ADDENDUM ONE

Project: Sullivan County Mary Hughes Elementary School Boiler Replacement

September 20, 2023

M-10

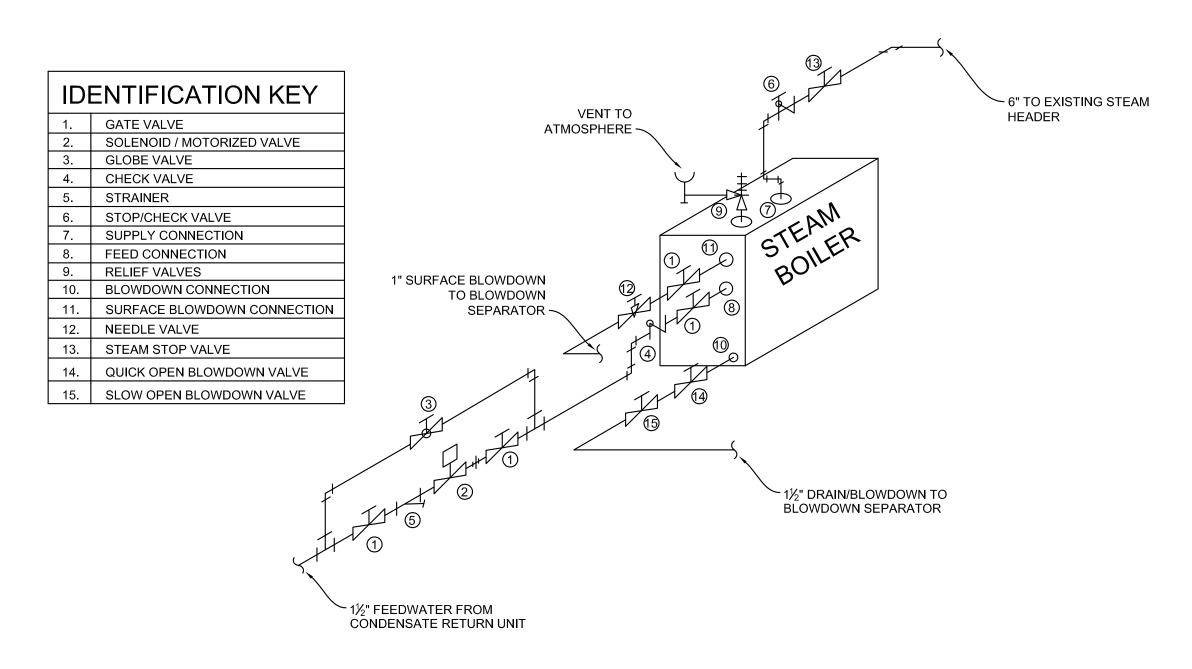
- 1. DRAWING M-10 See revisions marked Addendum #1.
- 2. DRAWING M-11 See revisions marked Addendum #1.
